REMARKS

The above amendments are made in response to the first Office Action mailed February 21, 2003, wherein:

FIG. 3

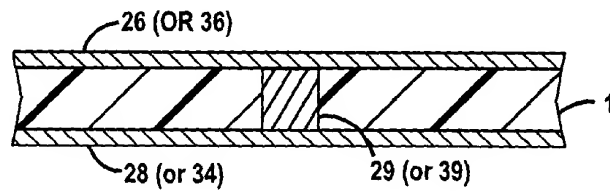
FIGS. 3 and 4: 26, 28, and 34.

FIG. 3: 39.

Applicants respectfully submit that reference number 50 was described with respect to FIG. 1 at page 4, lines 28-29 of the Specification as originally filed. With the Amendment, the Specification has been amended to include these reference numbers at points where the figures are described. In addition, FIG. 5 has been amended to change the reference number 20 to 20' so as distinguish the different configuration of the capacitive diaphragms 28' and 28". In addition, the Specification has been amended to address the other objections noted by the Examiner.

FIG. 4

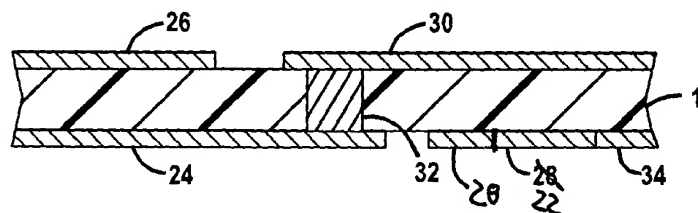
FIG. 4: 1, 24, and 30.

FIG. 8

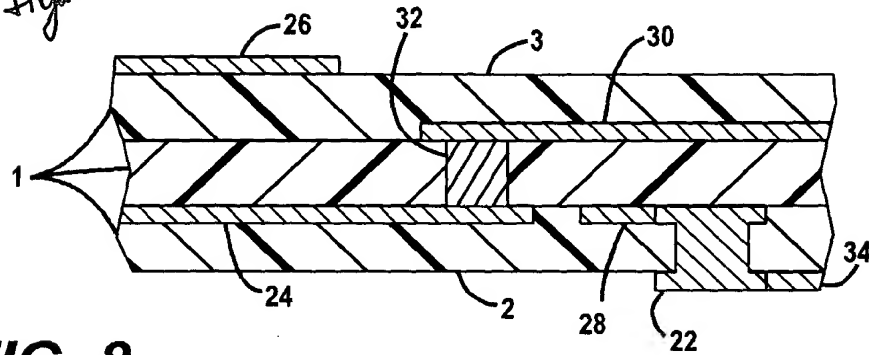
*Added
Figure*
